TITLE: <b>EXP VIEW DWG- BOWFLEX HVT</b>			
DRAWN: J.MORGAN	DOC. PART NO. 100551-W	PRODUCT SKU NO. 100551	REV. H
DATE 10/01/2018

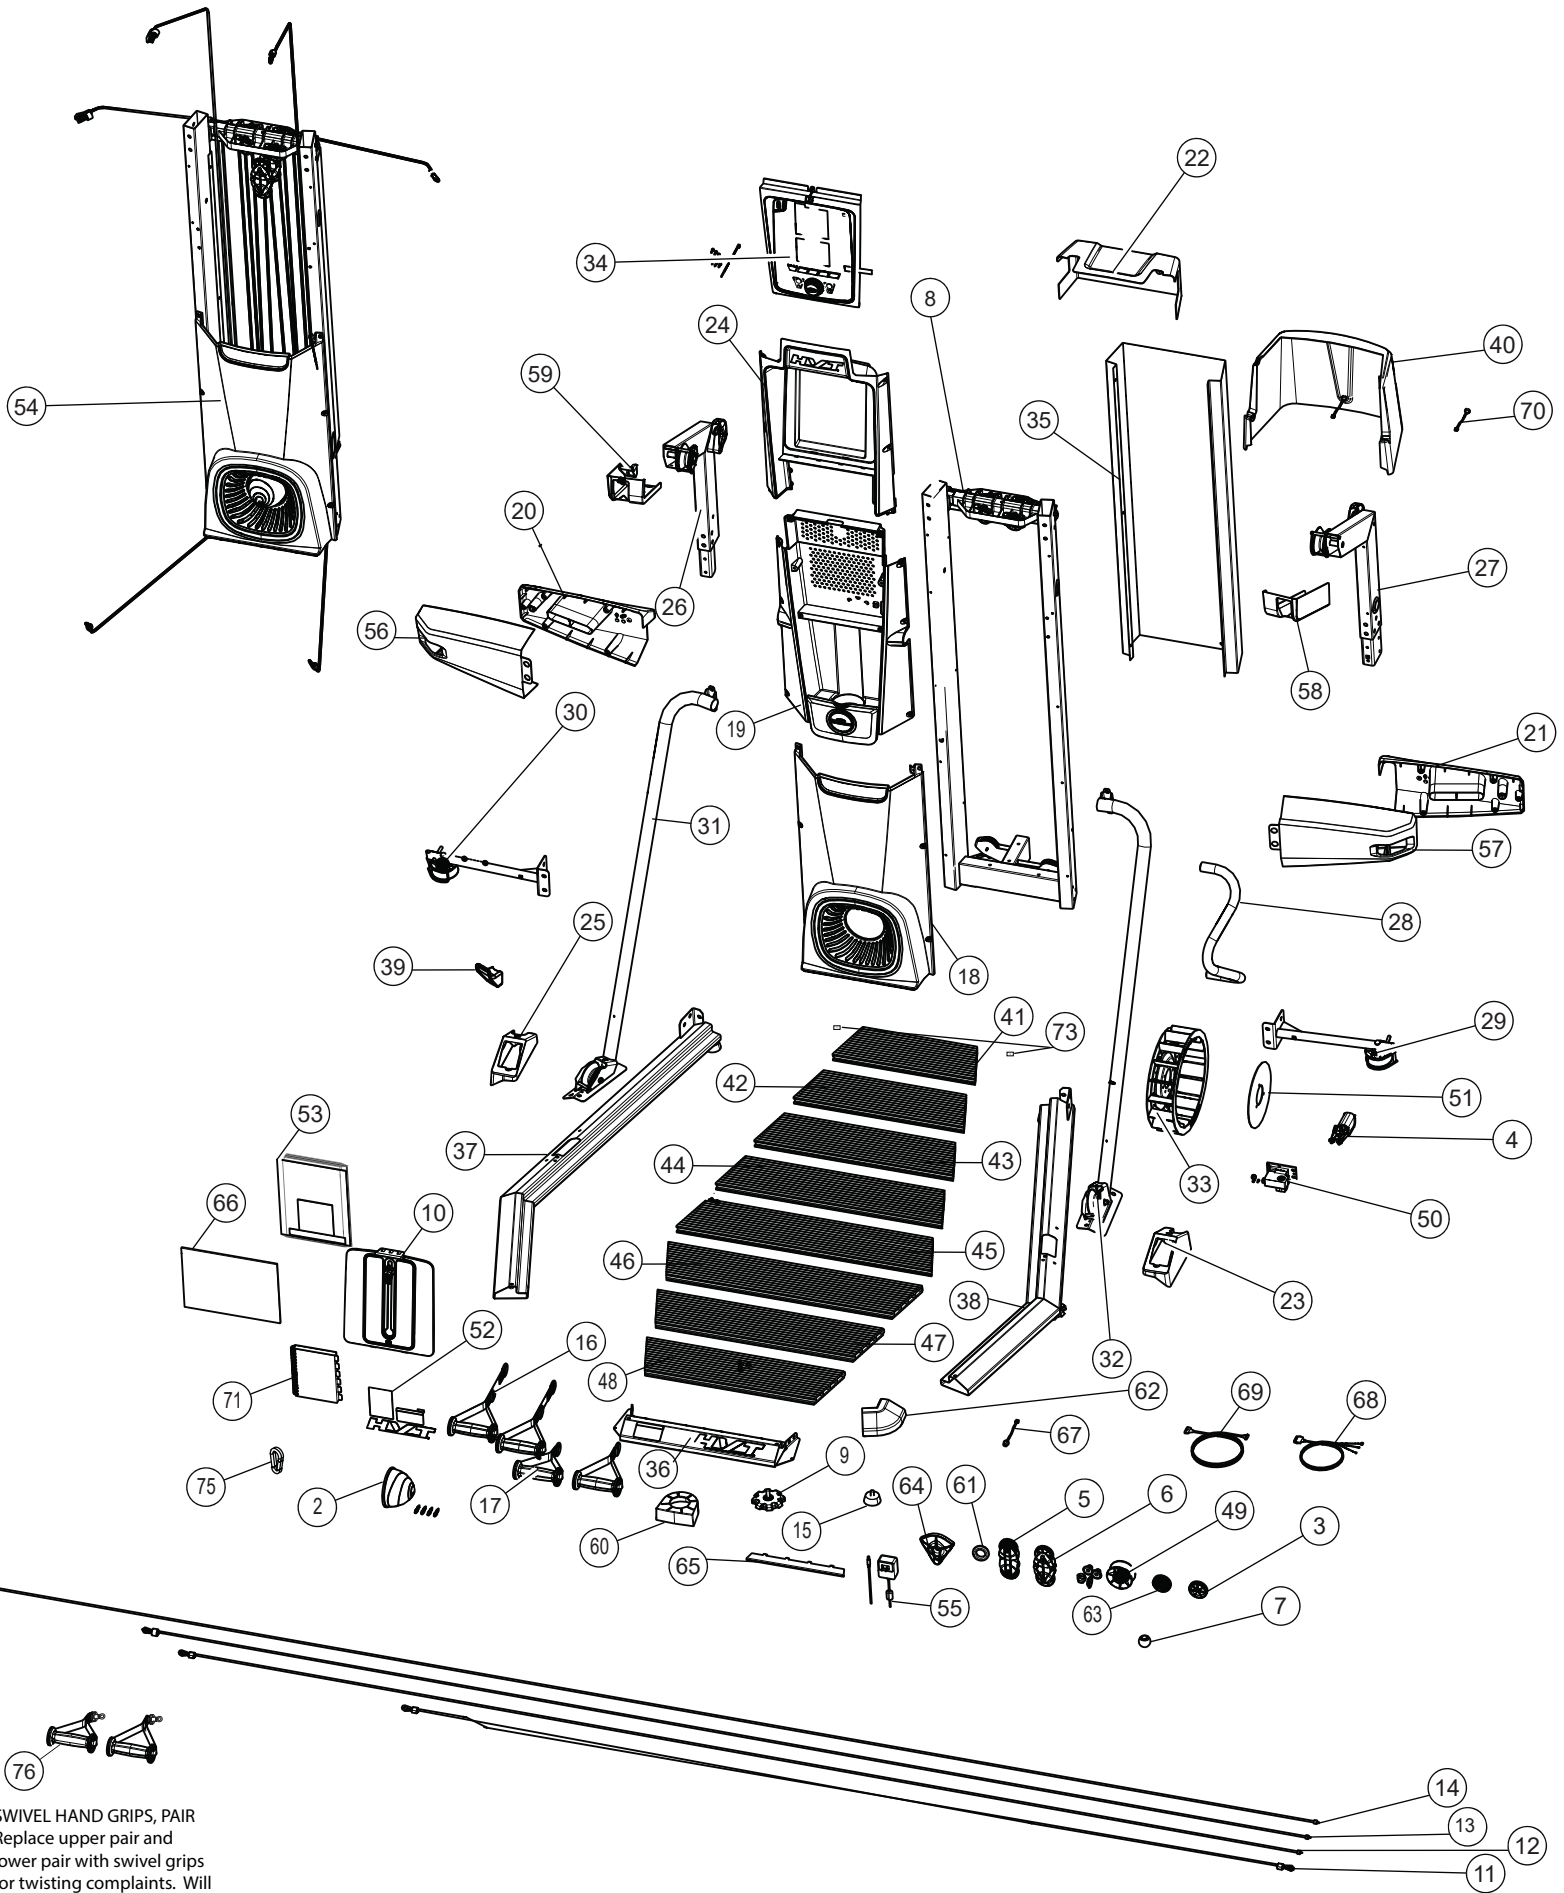
**76**  
**SWIVEL HAND GRIPS, PAIR**  
 Replace upper pair and lower pair with swivel grips for twisting complaints. Will lose lower grip length adjustment.
